MCGOWIN PARK SUBDIVISION

APPLICATION NUMBER 16 DATE December 5, 2013

REQUEST Subdivision

DETAIL SITE PLAN

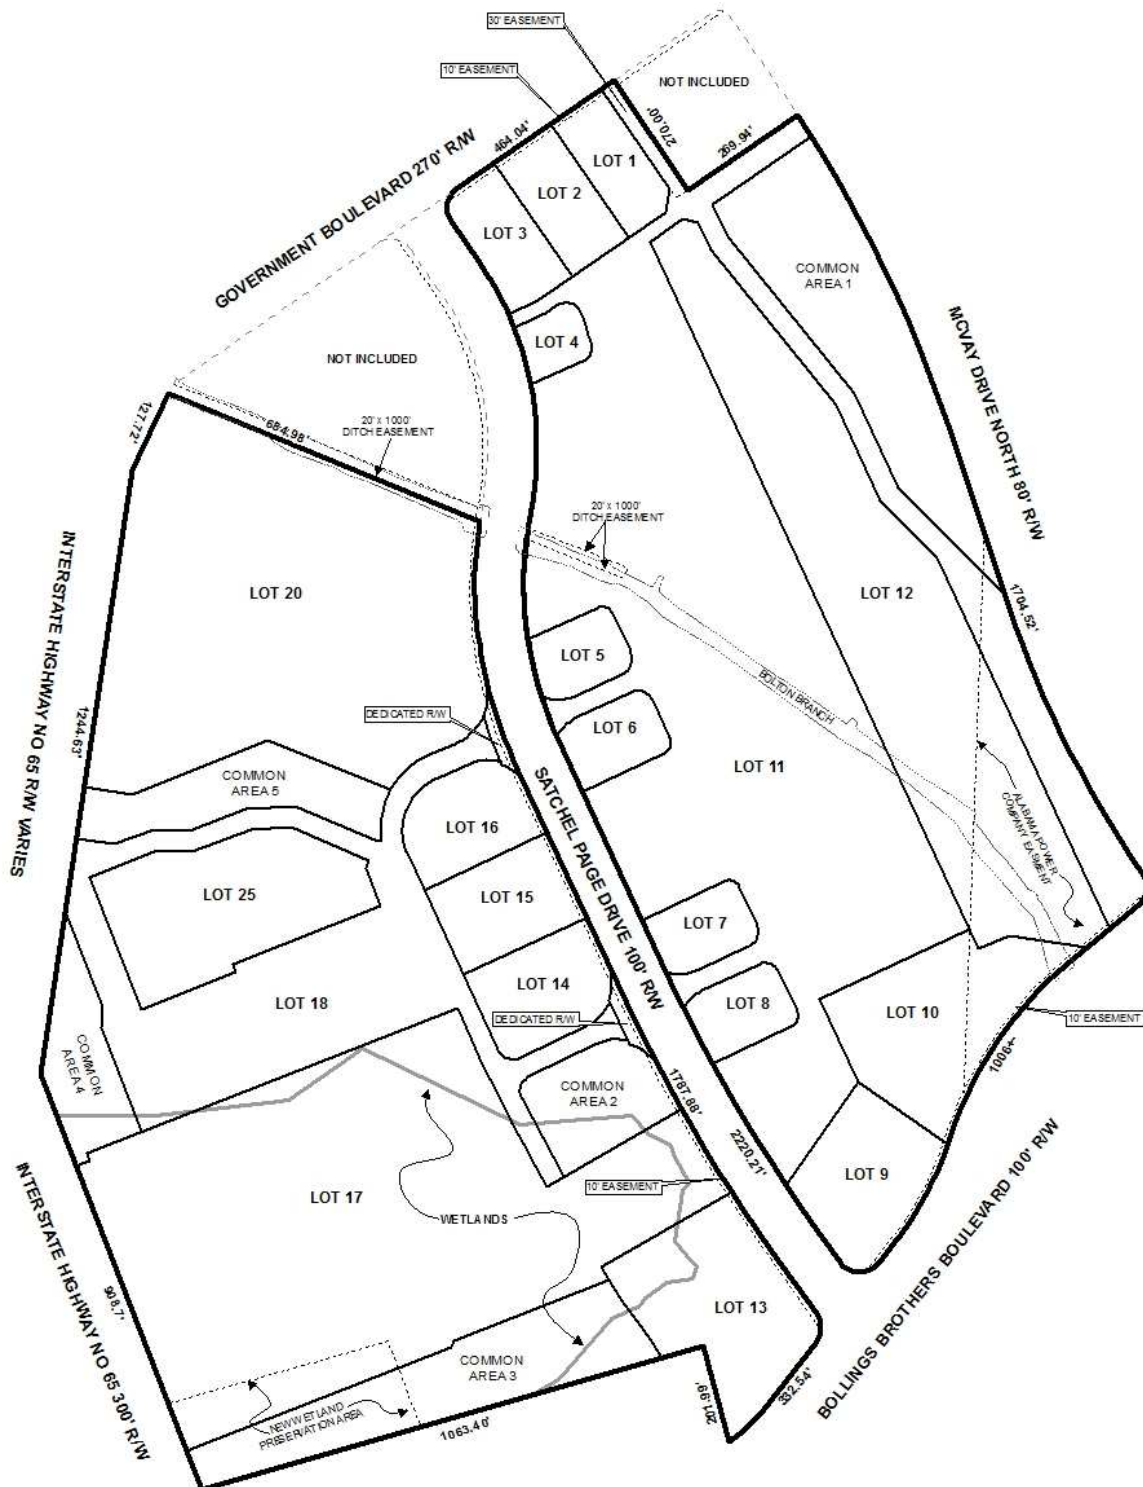
The 25-foot minimum building setback line is not depicted on the preliminary plat and was not addressed in the PUDs for the overall development. Therefore, the setback line should be depicted on the final plat, if approved, for all lots with frontage on a public street, as required by Section V.D.9. of the Subdivision Regulations.

Several drainage and utility easements are depicted on the preliminary plat. It should be noted that buildings and other permanent habitable structures are not allowed in easements, and a note stating such should be placed on the final plat, if approved.

Detention basin/common areas are proposed for the subdivision development. A note should be placed on the Final Plat, if approved, stating that maintenance of the detention basin/common areas, and any other common areas, are the responsibility of the subdivision's property owners.

- 3) revision of the plat to depict the 25-foot minimum building setback line for all lots with frontage on a public street, as required by Section V.D.9. of the Subdivision Regulations;

- 4) labeling of all common areas and detention areas, and placement of a note on the final plat stating that maintenance of the detention basin/common areas, and any other common areas, are the responsibility of the subdivision's property owners;

- 5) labeling of all drainage and utility easements on the site, and placement of a note on the final plat stating that buildings and other permanent habitable structures are not allowed in easements;
